Wisconsin Department of Transportation

Proposal #23: 5040-04-60
Hillsboro – Union Center
.02MI E CTH FF To B-29-59
STH 33
Juneau & Vernon County

This is Addendum No. 01, which provides for the following:

ADDENDUM NO. 01

Addendum No. 01
 ID 5040-04-60
 Revised Sheet 5
 June 5, 2017

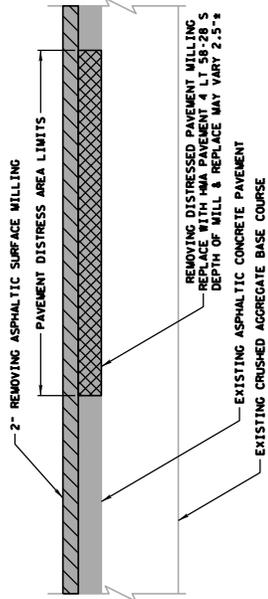
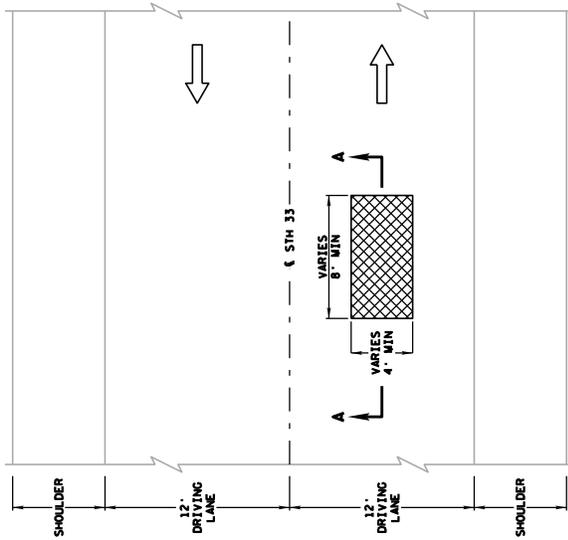
Revised Plan Sheets	
Plan Sheet	Plan Sheet Title (brief description of changes to sheet)
5	Construction Detail (added Removing Distressed Pavement Milling detail)
25	Removed bid items Removing Pavement Markings & Temp Pavement Marking Paint 4-Inch and added Temp Pavement Marking Epoxy 4-Inch

REMOVING DISTRESSED PAVEMENT MILLING
